Notice of Proposed Rule

South Florida Water Management District

40E-41.263: Conditions for Issuance of Permits in the C-51 Basin

PURPOSE AND EFFECT: Update the District's C-51 Basin rules to reflect changes in basin

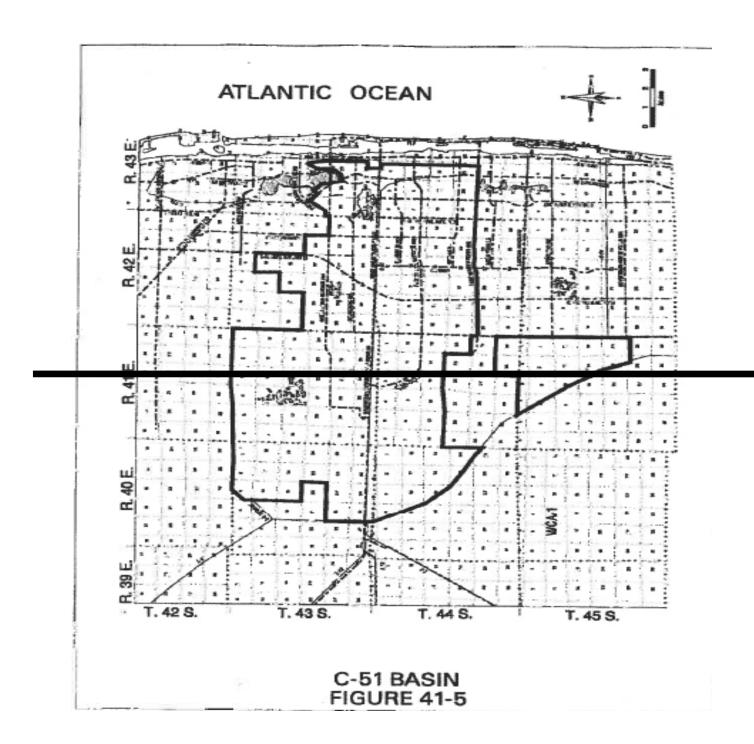
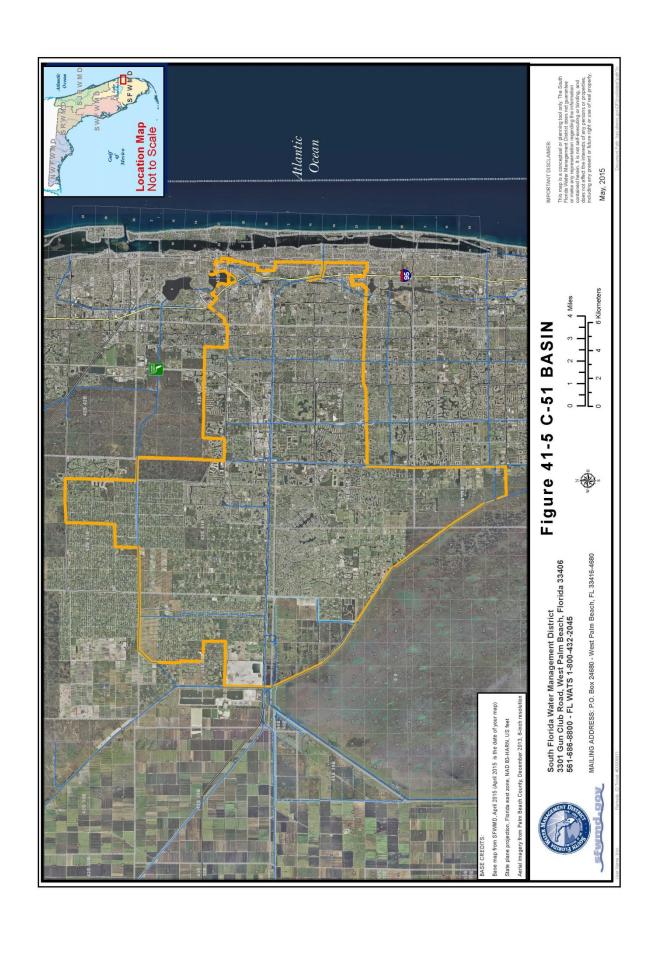
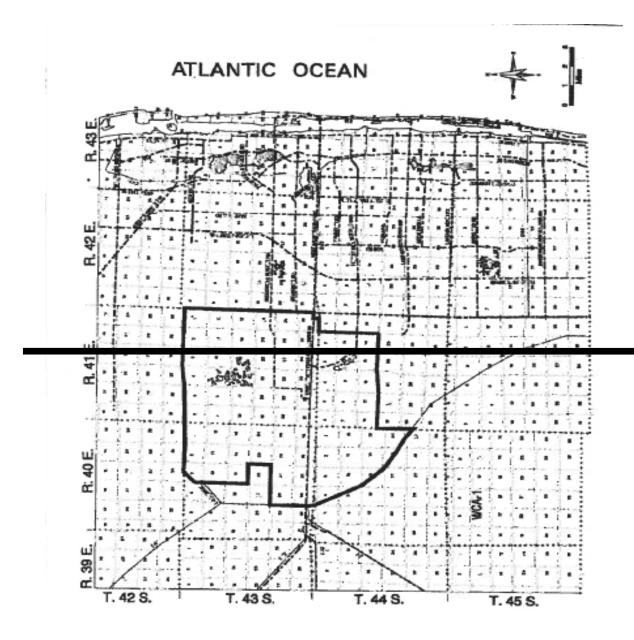
SUMMARY: The proposed rules update Figures 41-5, 41-6, 41-7 and 41-8 to revise sub-basin

boundaries and the overall boundary of the C-51 Basin due to the addition or subtraction of areas

- (1) "Basin" means the C-51 Basin as legally described in Rule 40E-41.223, F.A.C., (Basin Boundary) and as depicted on Figure 41-5 [ADD EFFECTIVE DATE] [ADD HYPERLINK], incorporated by reference herein.

C-51 BASIN FIGURE 41-6

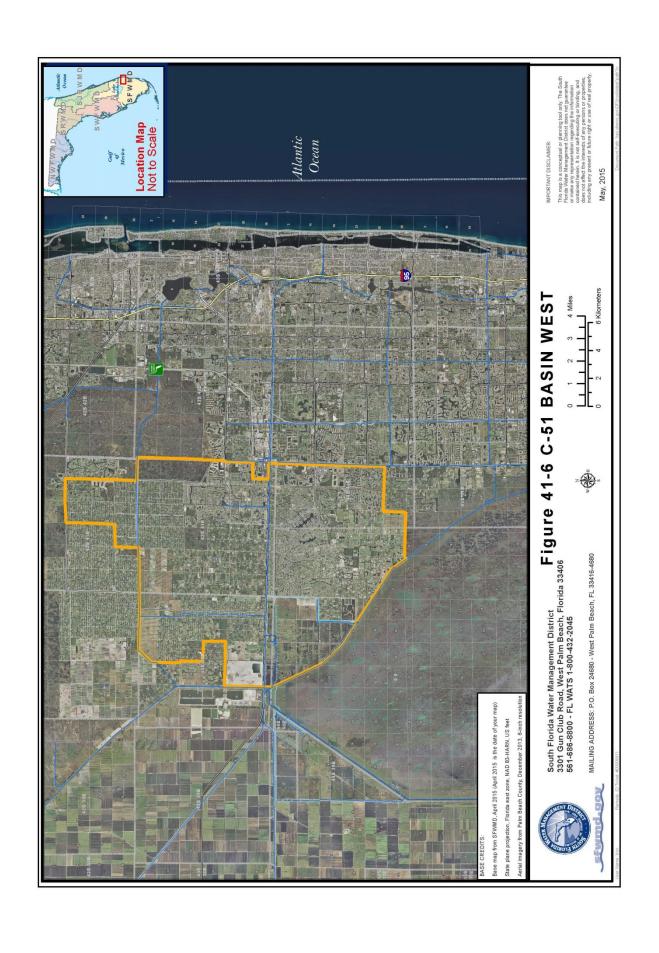
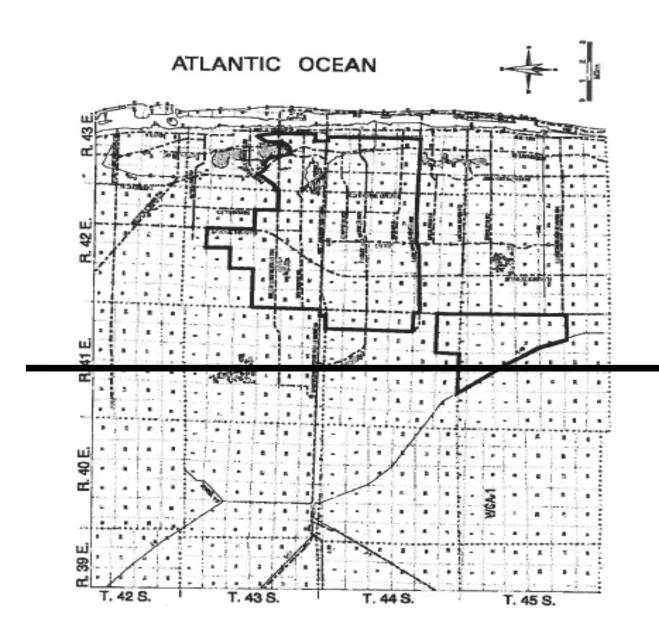
from the basin as determined by contemporary discharge patterns; revise the 10-year, 3-day peak

- (2) "Western C-51 Basin" means that portion of the C-51 Basin west of State Road Seven as described in subsection 40E-41.223(1), F.A.C. (Western Basin Boundary) and depicted on Figure 41-6 [ADD EFFECTIVE DATE] [ADD HYPERLINK], incorporated by reference herein described in subsection 40E-41.223(1), F.A.C.

C-51 BASIN FIGURE 41-7

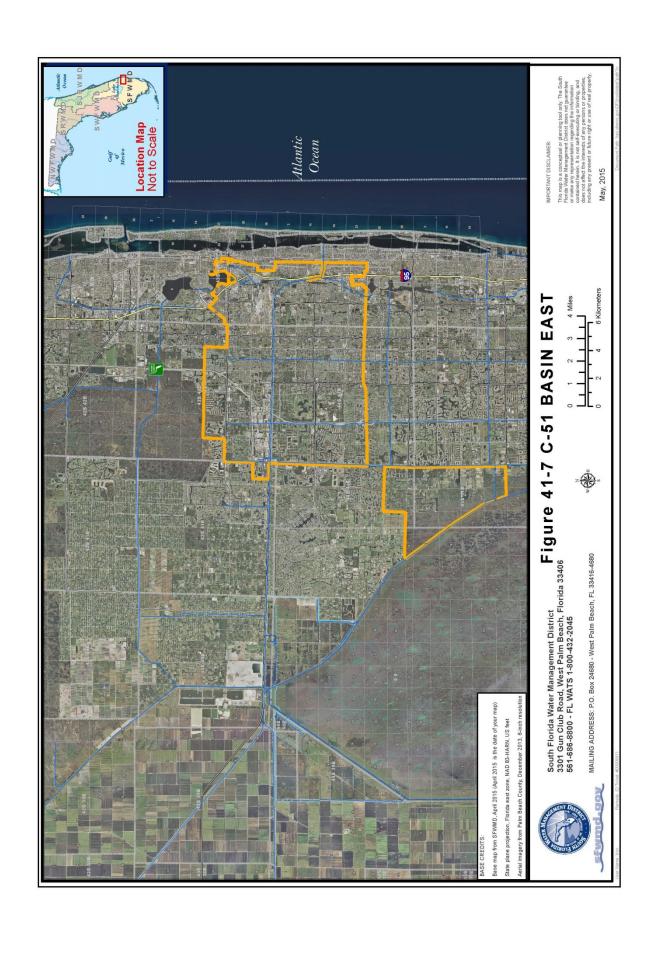
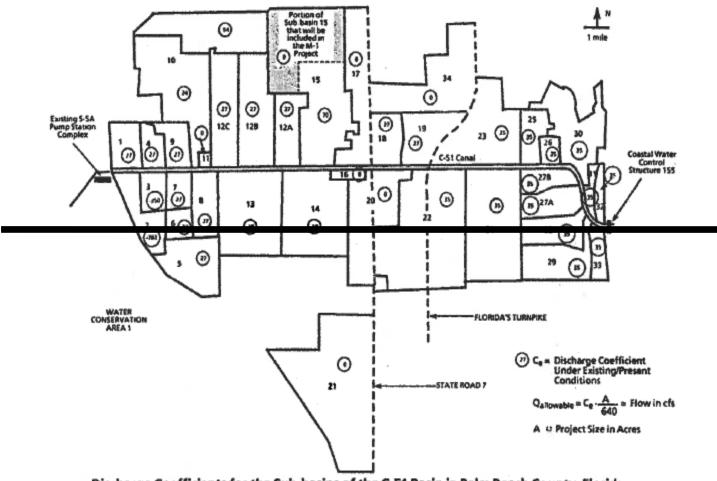
- (3) "Eastern C-51 Basin" means that portion of the C-51 Basin east and west of State Road Seven as <u>described in subsection 40E-41.223(2)</u>, F.A.C., (Eastern Basin Boundary) and depicted on Figure 41-7 [ADD EFFECTIVE DATE] [ADD HYPERLINK], incorporated by reference <u>herein described in subsection 40E-41.223(2)</u>, F.A.C., (Eastern Basin Boundary).

Figure 41-8

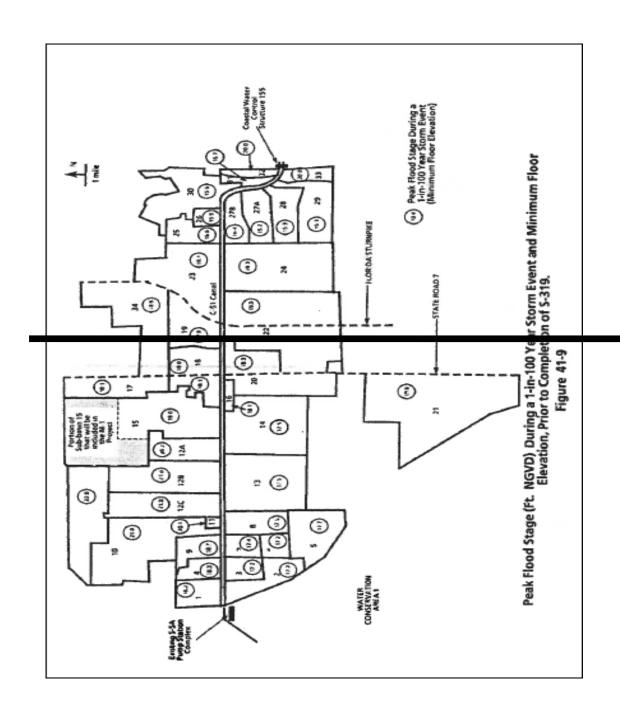
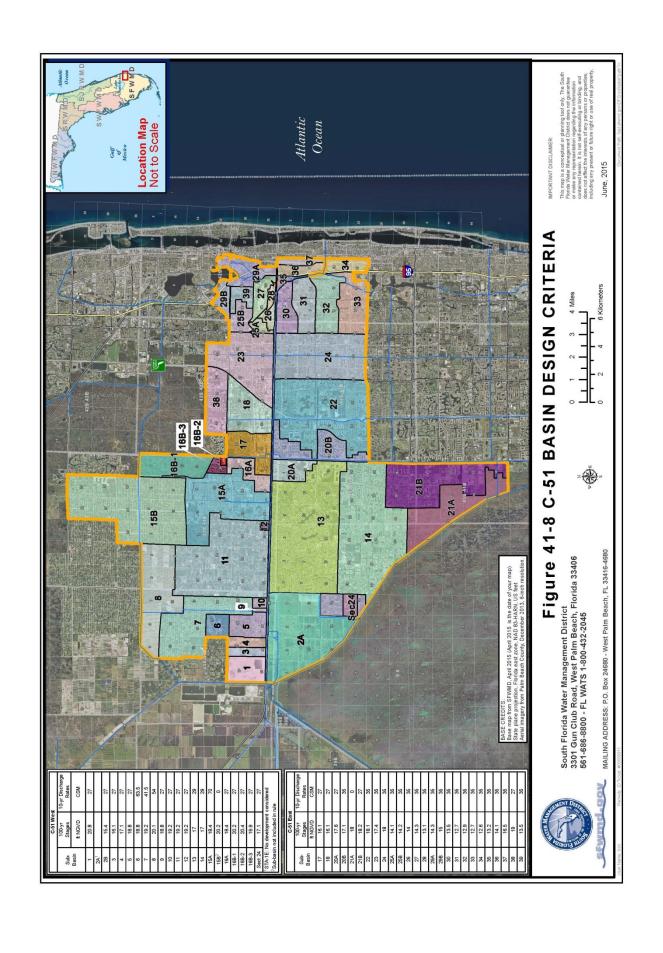
discharge coefficients used in establishing the 10-year, 3-day allowable peak discharge rate;

consolidate Figure 41-9 with Figure 41-8; change the allowable discharge in Rule 40E-

(1)(a) The allowable discharge shall be based upon the post development discharge rate not exceeding the pre-development discharge rate during a design storm of a 10-year 3-day duration as depicted on Figure 41-8 [ADD EFFECTIVE DATE] [ADD HYPERLINK], incorporated by reference herein. Pre-development discharge rate shall be calculated by the formula:

- (2) Finished building floor elevations shall be above the most restrictive of the following:
- (a) The 1 in 100 year storm elevations as determined by peak flood stage of the C-51 Basin as depicted on the attached Figure 41-8 41-9,

- (b) and (c) NO CHANGE
- (3) No net encroachment into the floodplain shall be allowed. Any water storage volume removed from the floodplain must be accommodated by an equal volume of open storage compensation. Water storage volume shall be computed by utilizing Figure 41-8 41-9. For the

purposes of this part, the minimum volume of water which must be accommodated on site shall be that quantity equal to the volume stored below the level shown on Figure 41-8 41-9 and above the existing grades. Compensation for any reduction in soil storage also shall be accommodated on site.
